Service Bulletin

Bulletin No.: 25-NA-117

Subject: Click or Tick Noise Coming from the Heads Up Display or Upper IP Area

Brand:	Model:	Model Year:		VIN:		Engine:	Transmission:
		from	to	from	to		
Cadillac	Escalade Models	2025	2025	-	-	All	All
	Escalade IQ

6925112

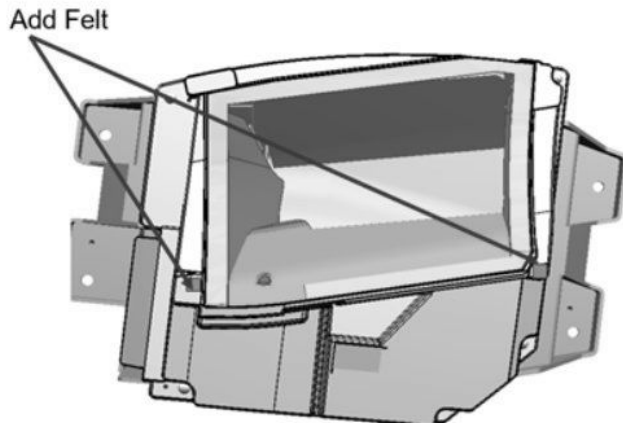
Involved Region or Country	North America
Condition	Some customers may comment on an itch, click, or tick noise coming from the Heads-Up Display (HUD) area over various road surfaces.
Cause	The cause of the condition may be interference between the HUD and IP Trim Panel extension.
Correction	Install felt tape to the HUD housing in the locations shown below. Note: Only apply the felt tape to the two locations shown below.

2. Install 2 pieces of felt roughly 10mm x 10mm x 3mm in the locations shown above.
3. Reinstall the Instrument Panel Extension. Refer to *Instrument Panel Extension Replacement* in Si.
